The Old Forge  
Mendlesham Road  
Brockford  
Stowmarket  
IP14 5NU

Proposed Repairs to Brick Plinth  
V0.1

This has been prepared to discharge a condition in the Listed Building Consent Application DC/23/05940 which states that :

### Proposed Repair

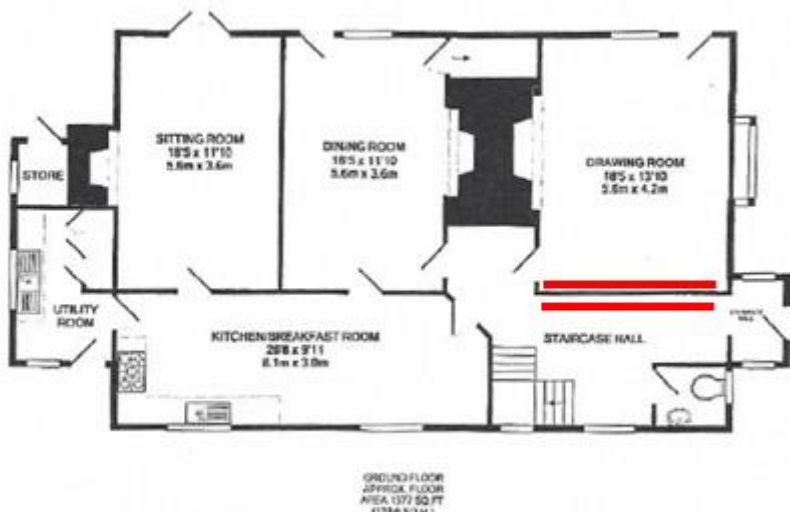
*Firstly, after advice was given to remove the concrete from the internal elevations of the plinth, it appears that the plinth has been damaged by the concrete render, and many of the bricks are delaminated due to water damage. Many of these will likely need to be carefully removed and replaced. The plinth is a mix of modern brickwork in places with some historic brickwork, although now severely damaged. It seems likely that much of the brick plinth will need to be repaired. There is also some unusual air bricks on one elevation, which will need further consideration, as discussed.*

It appears that concrete screed has been laid throughout the historic core of the property and extended up and over the plinth. This concrete is now cracked due to water damage and needs to be removed. Some of the screed has flaked away and shows a likely historic brick floor below the surface. This flooring should be retained where possible throughout the works.

Regarding the current application, Nic had produced an appropriate repair for the soleplate, taking on board my comments about retaining as much as possible from the former entranceway (including the uneven worn top layer, which shows years of feet stepping over the threshold). I am content that this work is considered appropriate, and that steps have been taken to mitigate or avoid harm to the significance of the building. This detail can be resubmitted with any future applications.

To maintain the stability of sections of soleplate and to reduce impacts to the unstable wattle and daub walls above, it is proposed to completely replace the top layer of bricks in each section with handmade Bulmer bricks (2.5 inches) as per the red line below. The plan is to carefully chisel out and remove 3 bricks at a time and replace and point with lime mortar along the length of the plinth. The bricks at the lower level will be repointed in situ. The plinth will then be rendered with Lime which will protect the bricks from any damage as the area is subject to heavy use.
